January 16, 2015

Request for Confirmation Sample Frequency Modification for Treated Soil at the Defense Fuel Support Point Norwalk, 15306 Norwalk Boulevard, Norwalk,

California (SCP NO. 0286A, Site ID NO. 16638)

Figure -1
Treatment Row Sampling Locations

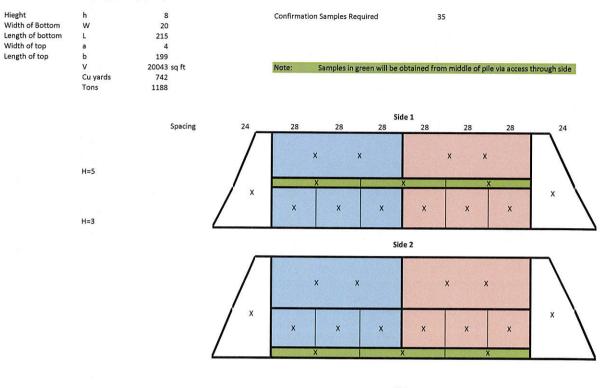
Based on the discussion and RWQCB review of the alternatives, it was mutually agreed the grid configuration as identified in the attached Figure 1 would provide an acceptable density of data to confirm a treated stockpile was suitable for reuse. This assumes the combined discrete values meet or exceed the 95% upper control limit (UCL) as compared to the soil cleanup goals as prescribed in the LARWQCB correspondence dated July 12, 2012.

The attached grid figure shows the locations of 35 discrete sample points for a typical stockpile size of 750 cu yds. A detailed sample strategy document addressing confirmation sampling for both treated soil and soil assumed clean will be provided on or before February 15, 2015, as
